CITY PLAN COMMISSION**THURSDAY, November 20, 2025****FILE NUMBER:** PLAT-25-000125**SENIOR PLANNER:** Hema Sharma**LOCATION:** Lovedale Avenue, east of Harry Hines Boulevard**DATE FILED:** October 23, 2025**ZONING:** MF-2(A)**CITY COUNCIL DISTRICT:** 2**SIZE OF REQUEST:** 0.384-acres**APPLICANT/OWNER:** Olerio Interest, LLC

REQUEST: An application to replat a 0.384-acre tract of land containing all of Lots 18 and 19 in City Block C/2366 to create one lot on property located on Lovedale Avenue, east of Harry Hines Boulevard.

AERIAL MAP

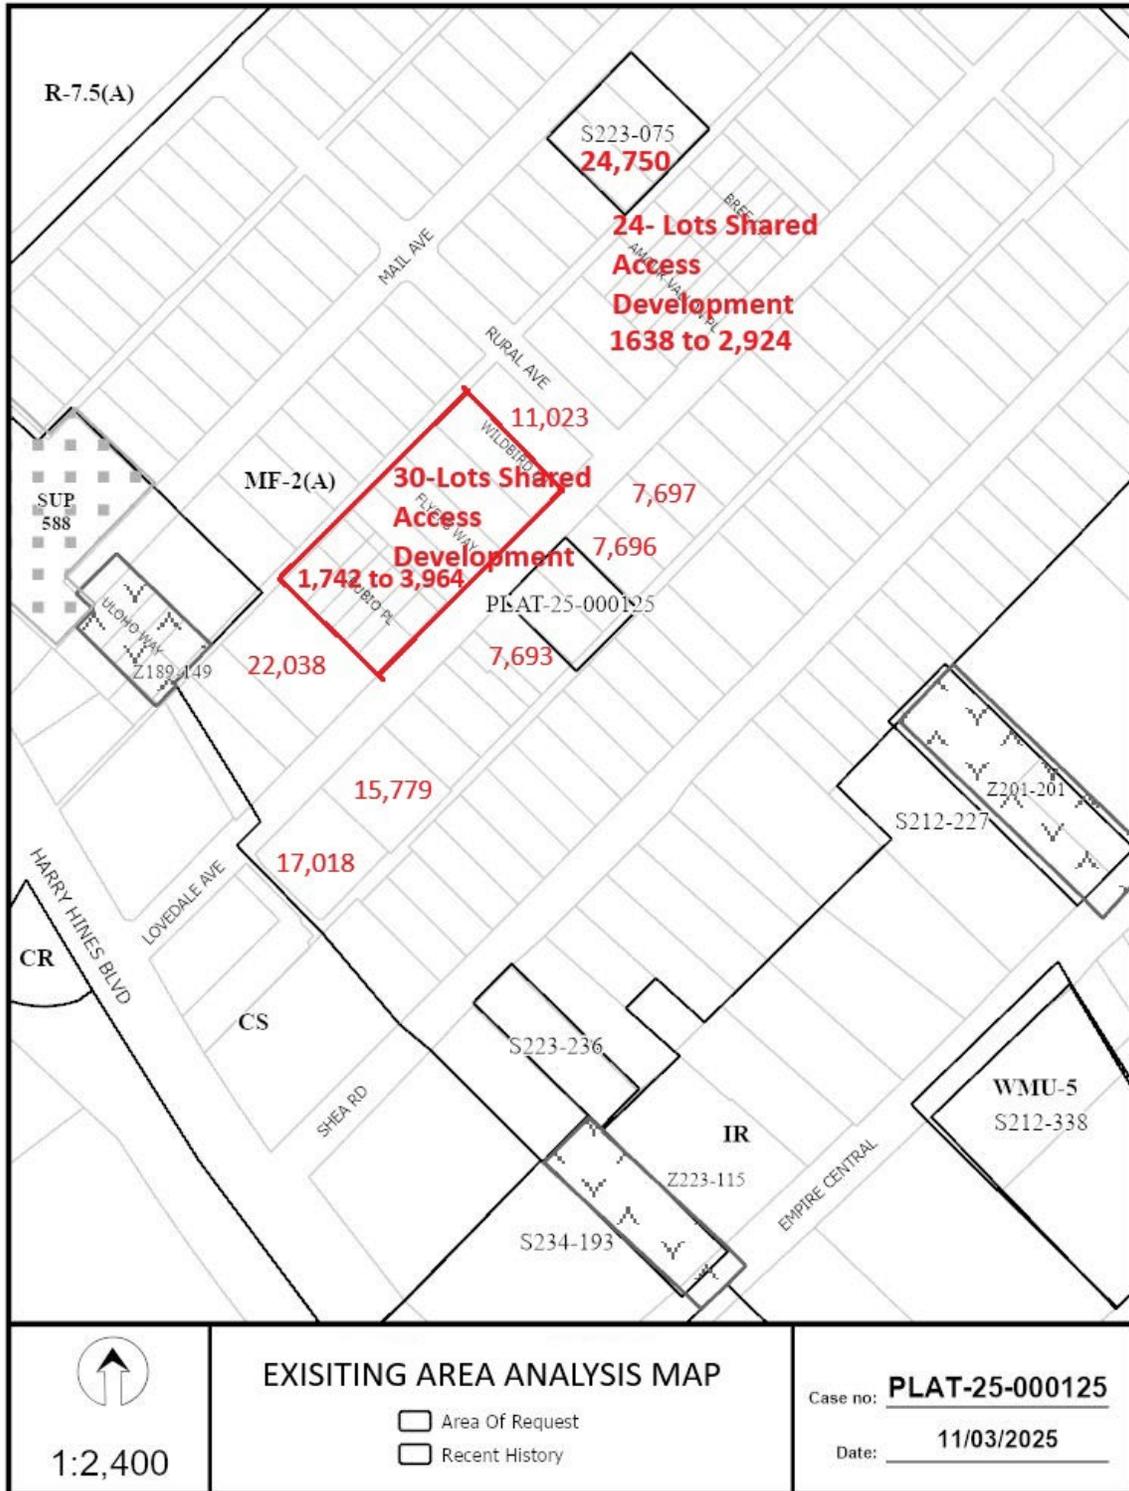
Staff finds that there is a variation in lot pattern within the immediate vicinity of the request (*Refer to the existing area analysis map and aerial map*). The request complies with the zoning requirement of the MF-2(A) Multifamily District and is in compliance with Section 51A-8.503; therefore, staff recommends approval subject to compliance with the following conditions
